# NORTHEAST UTILITIES

August 30, 1985

Millstone Nuclear Power Station, Unit No. 2  
Inservice Inspection and Testing Program  
Supplemental Relief Request Information

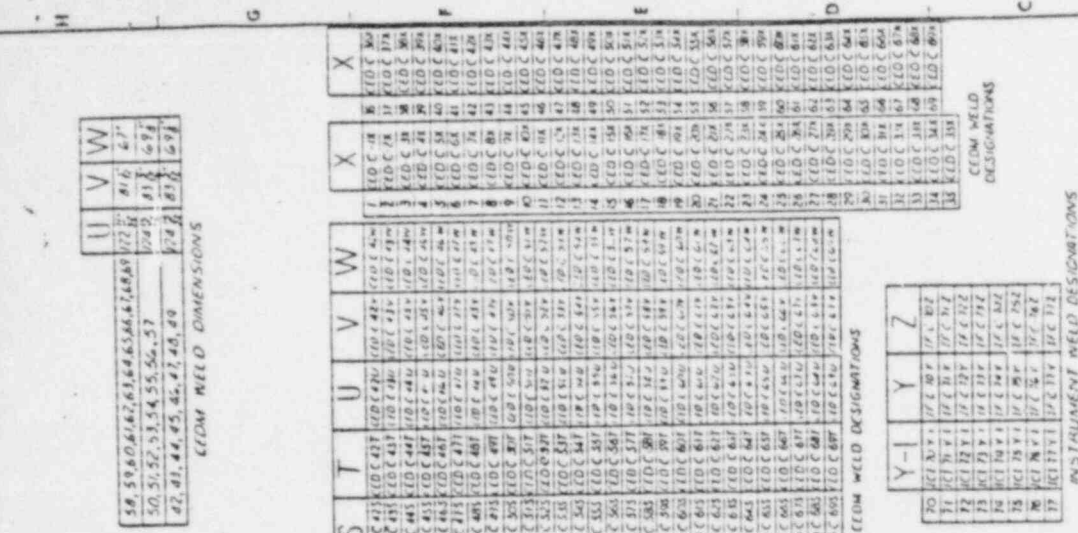
Relief is requested from performing the code required volumetric and surface examinations on several of these CRD housing welds for the following reasons:

1. The lower CRD housing weld (W) is partially recessed into the reactor vessel head and less than 40 percent of the weld can be examined. See attached Drawing 25203-29527, Sheet 2 for details.
2. Surface examination techniques would be extremely difficult to perform on this weld as the adjacent CRD housings are too close to one another to permit accessibility.
3. Subsequent cleaning of any surface examination technique would be questionable due to the crevice in the recessed area.

Proposed Alternative Examination:

The accessible welds in the above CRD housings will be examined. The integrity of the inaccessible welds will be verified by visual examination during the system hydrostatic test.
